Below you will find the latest information that is important to know when bodybuilding on a Scania vehicle.

EG TOP-MOUNTED PTO FOR GW GEARBOXES – DRIVING OPERATION ENABLED

Example of sticker position on a CNG gas tank

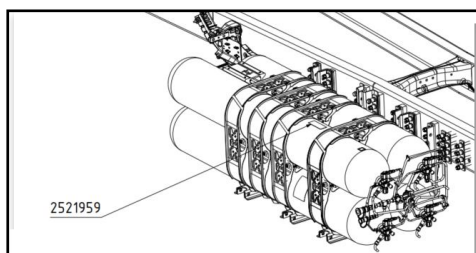
To improve safety awareness among bodybuilders, the information sticker for bodybuilder portal currently used on rigid chassis will also be introduced on articulated chassis with gas engines.

The sticker is mounted on the gas tank. On vehicles equipped with rack behind the cab, it is mounted on the left-hand side of the rack. This change applies to chassis produced from the beginning of November 2026 onwards.
